File 1993-0008

Name: Visitor's Convention Center - SPR- 740 Horizon Drive

VCB  
DRAINAGE CALCCS

# SOUTH SIDE

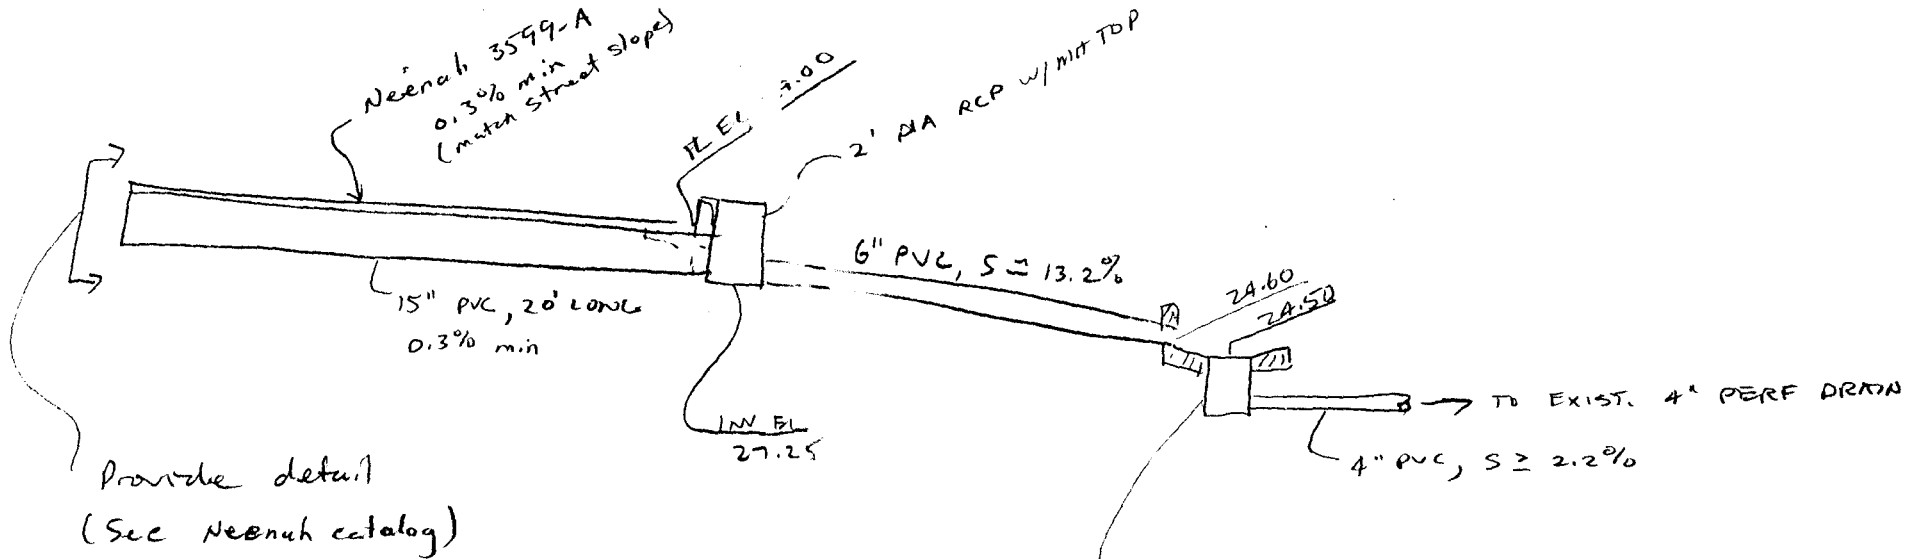
CHANGE THIS CONCEPT DWG INTO SOMETHING REAL, TO SCALE

No orifice req'd.  
Outlet pipe controls  
hydraulics.

# NORTH DRAIN

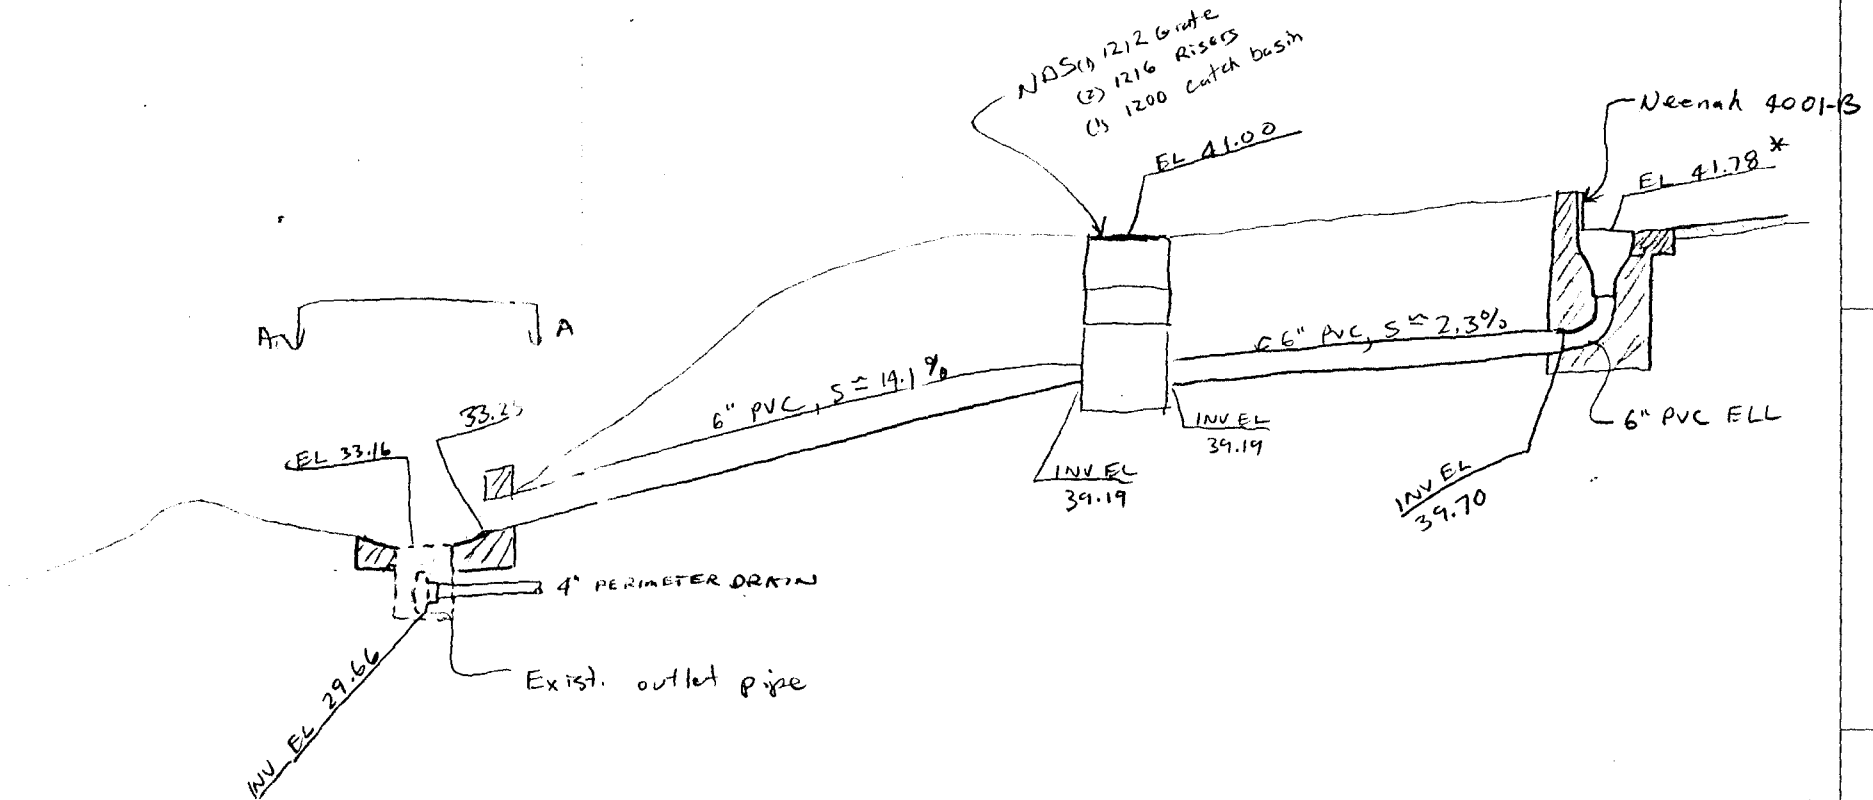
CHANGE THIS CONCEPT DWG INTO A REAL PROFILE DRAWING (TO SCALE)

\* You have not provided an adequate grading plan, but extrapolating contours, I've started with 41.78.

CONCEPT ONLY. VERIFY  
SIZE/SHAPE/CONF. SURROUND  
OF INLET IN FIELD AND DRAW  
TO SCALE WITH APPROPRIATE  
DESIGN

Tee?

Adaptor?

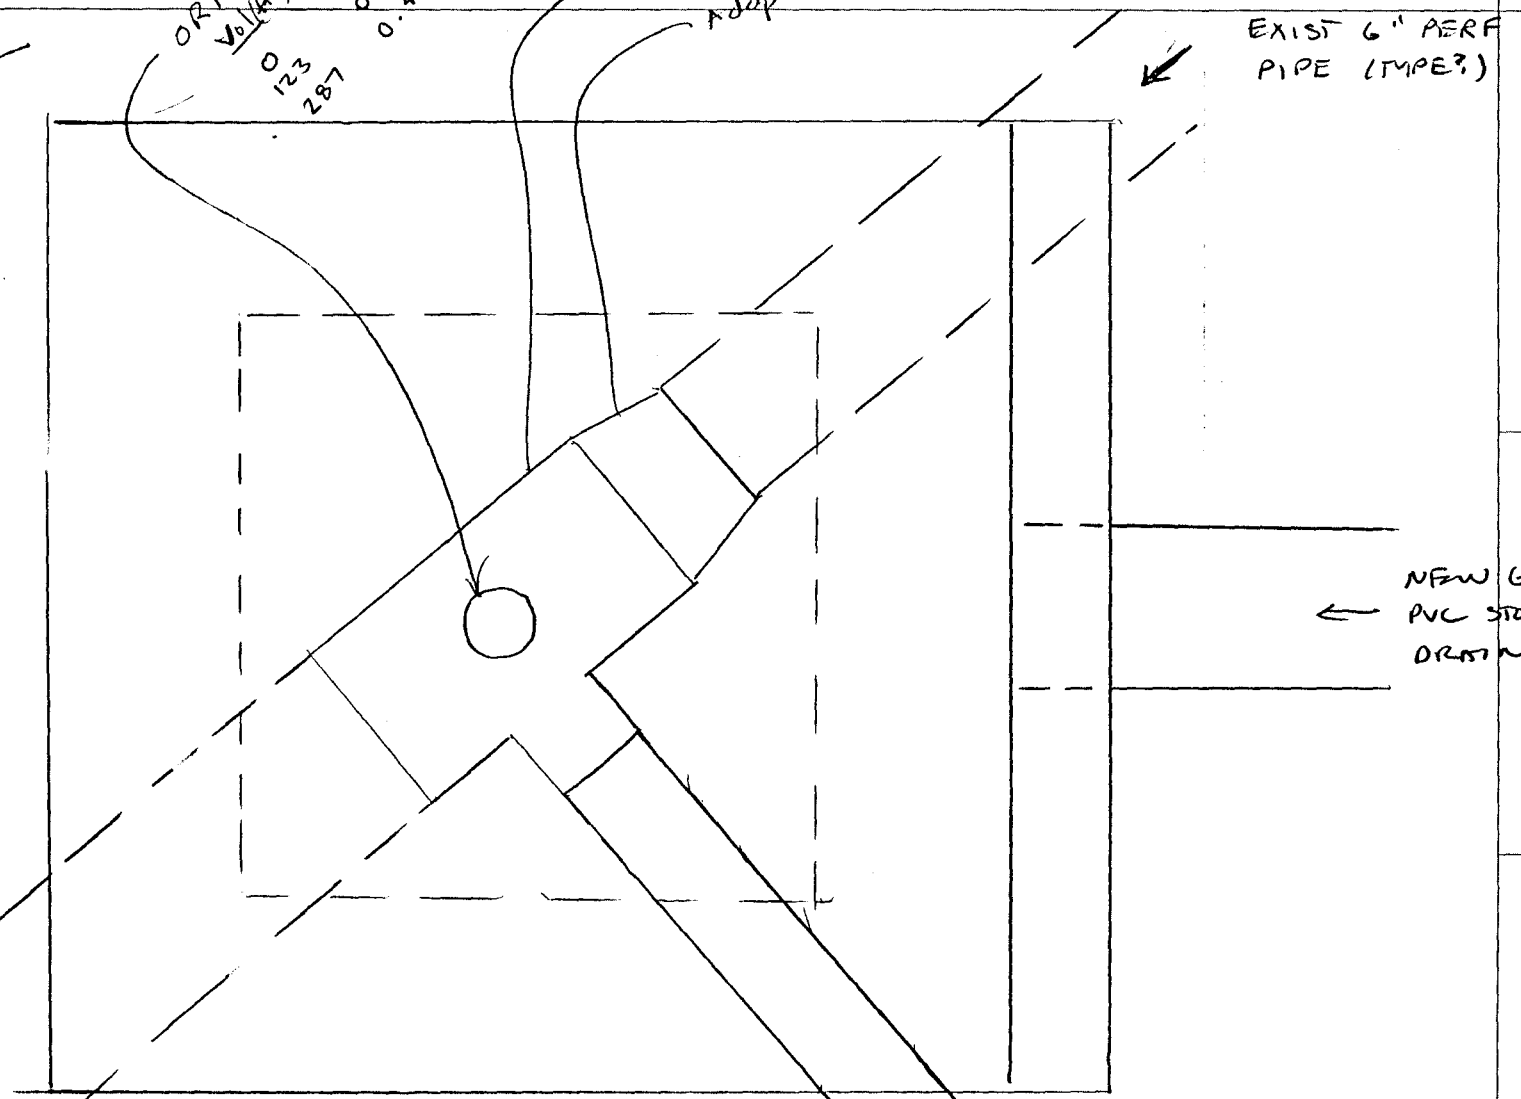
EXIST 6" AERF  
PIPE (TMPE?)
